Response to NRC Request For Additional Information

HADDAM NECK

Re: Licensee Response to Bulletin 88-02

JAYCOR Report J1681-91-001R0

Figure 1-1. Damping of tube bundles in two-phase cross-flow: Comparison with results of Axisa [6] for steam-water. Normal square: \square ; parallel triangular: \triangle ; normal triangular: \triangleright . Reprinted from Reference 6, Pettigrew, Taylor and Kim.

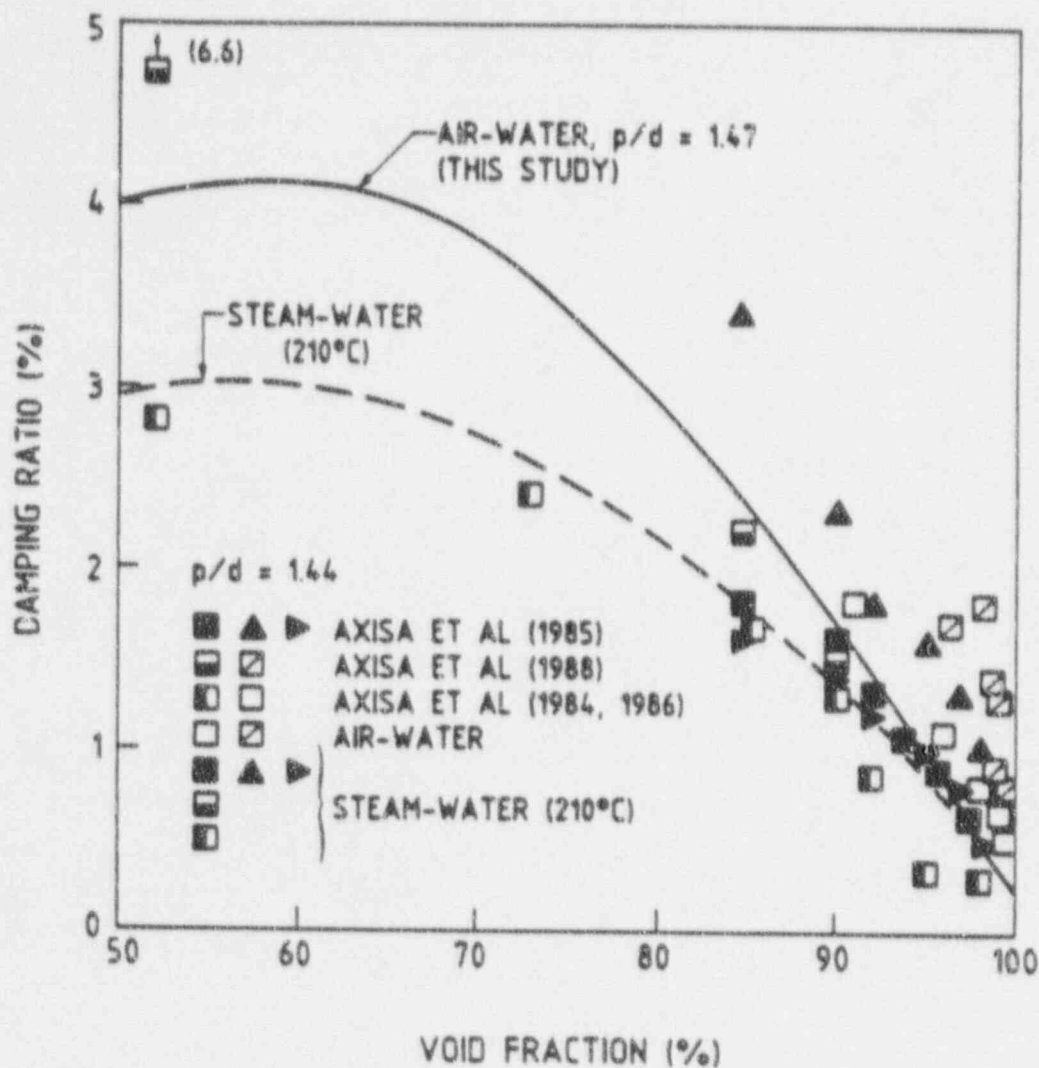
1. Response to NRC Item 1: North Anna Model Validation

The selection of a suitable value for the total damping ratio, ζ , is not so straightforward. For further details, see the response to NRC Item 5 presented in Section 5. Here, it should suffice to mention that we have employed an empirical curve of total damping versus void fraction, shown in Figure 1-1 (Figure 17 of Reference 2), taken from data measured by Axisa [6] for steam-water two-phase flow at 210°C. In conjunction with Figure 1-1 we have used an average value of void fraction applicable to the three-dimensional space occupied by the ensemble of tubes of interest (rows 7-11 of the Model 51) in the U-bend region, taken from the ATHOS3 code prediction. For the Model 51 calculation, the appropriate value of average void is $\alpha_{avg} = 0.86$. This average void pertains to the group of tubes examined, and may differ from the average value for the entire U-bend region. The associated value of total damping is obtained from Figure 1-1 as $\zeta = 0.017$, applicable to our North Anna evaluation.

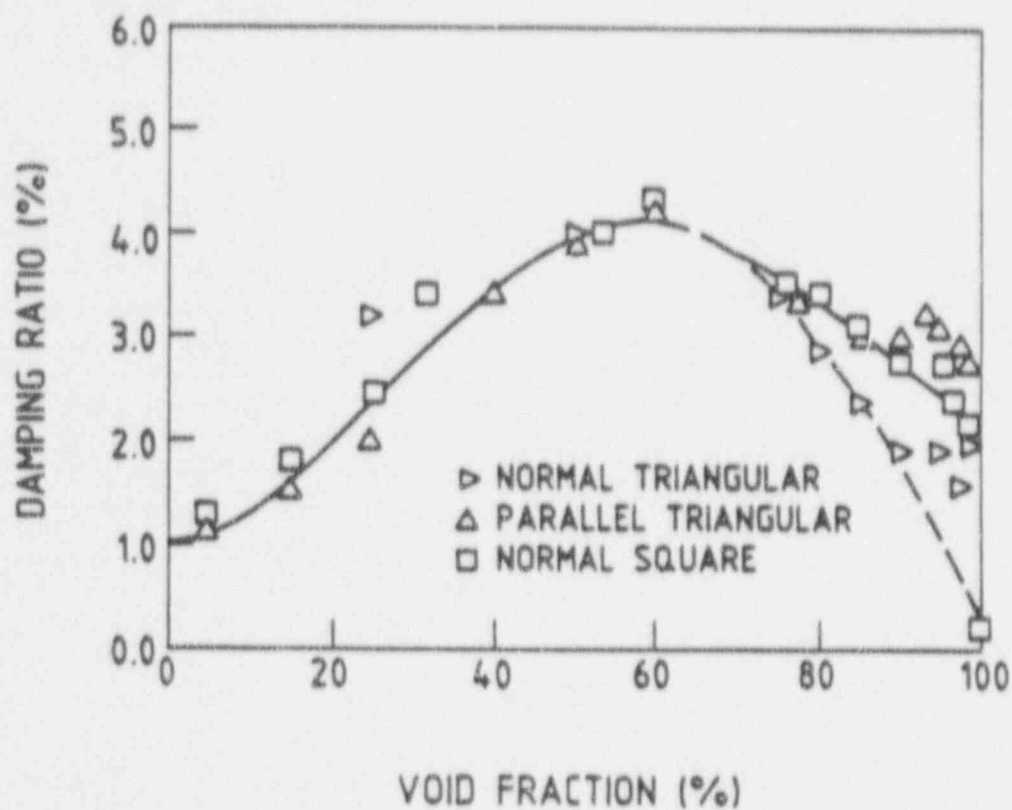
5. Response to NRC Item 5: Selection of Total Damping Ratio

The value of total damping ratio of 0.03 was inferred from Figure 14 of the Pettigrew, et al. paper, which we present here as Figure 5-1. The experimental data for a normal square pitch (square symbols) were used in conjunction with an average void fraction for the entire U-bend region of 0.88. Figure 5-1 applies to damping measurements in air-water mixtures with confinement ratios of $P/D=1.47$.

This paper is Reference 2 of the current report. Note that Figure 5-1 also appears as Figure 15 in Reference 2.
